Broadcast Products Technical Bulletin 20-2010-026

SUBJECT: HORIZONTAL BAR NOISE WITH 25PsF/29.97PsF

MODEL: *HDC1500//UL*
HDC1500/L
 HDC1500/L
 HDC1500/L1
 HDC1500/L2
HDC1500/T
 HDC1500/T2
HDC1550//UF
HDC1550//UF1
HDC1550/F
 HDC1550/K
 HDC1550/K1
 HDC1550/K2

Figure 1

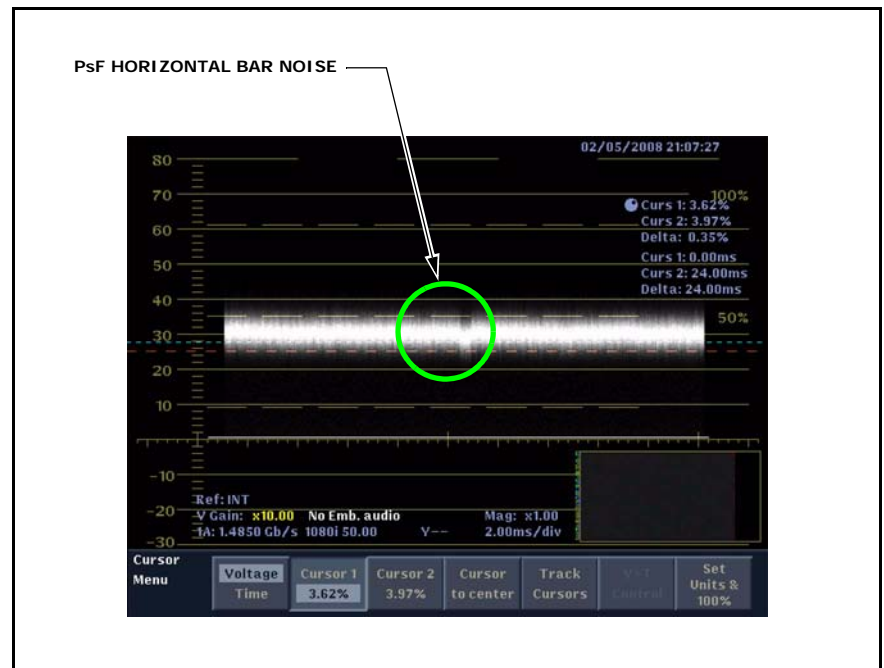
Faint horizontal bar noise may appear on the screen while running in 1080/25PsF, 1080/29.97PsF modes. (See Figure 1.)

NOTE: The amount of noise differs among individual cameras.

Figure 2

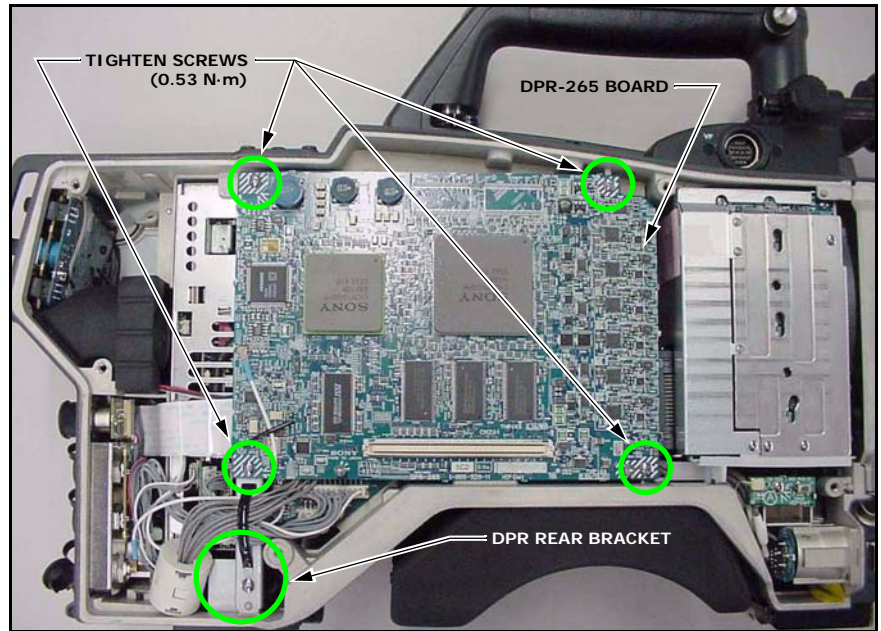
2. Tighten the four M2.6×5 screws that affix the DPR-265 board with a tightening torque of 0.53 N·m (5.3 Kgf·cm). (See Figure 2.)
3. Tighten the M2.6×5 screw that affixes the DPR rear bracket to the chassis with a tightening torque of 0.53 N·m (5.3 Kgf·cm). (See Figure 2.)
4. Reattach the outside panel assembly.

Figure 3

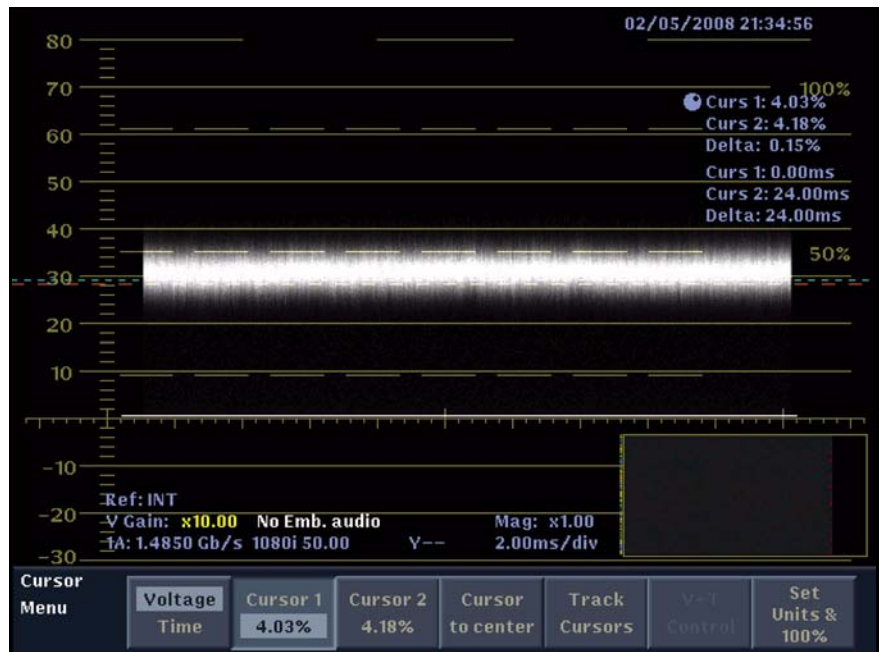
- Video output is normal in 1080/25PsF, 1080/29.97 PsF modes.
- Horizontal bar noise is improved. (See Figure 3.)
